S E R V I C E N O T E

8751A Network Analyzer**Serial Numbers:** 0000J00000 / 9999J99999**Modification to extend the A7 board using P/N 08751-66594****Situation:**

Figure A. Extender Board Modification

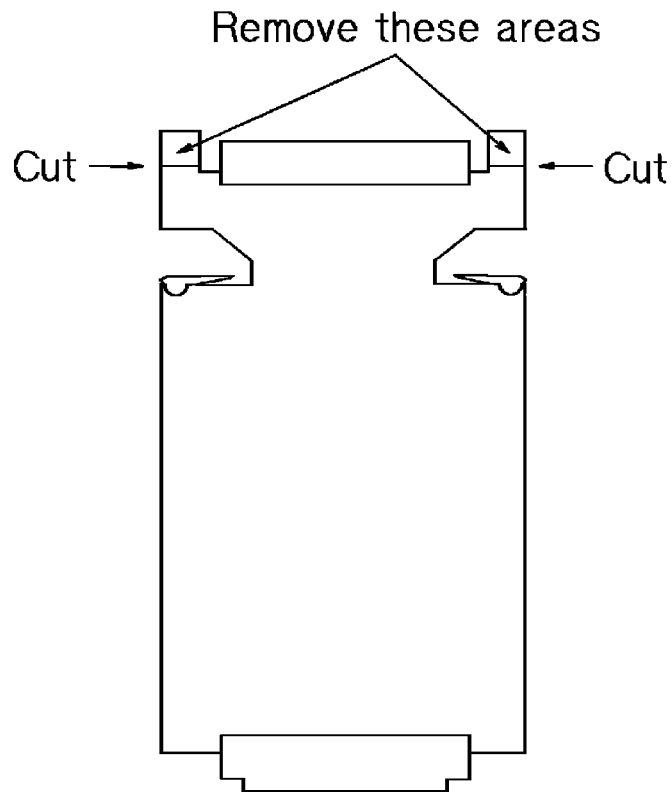
If you need to extend the A7 board, extender board P/N 08751-66594 can be used, but you will have to remove the areas shown in the following diagram.
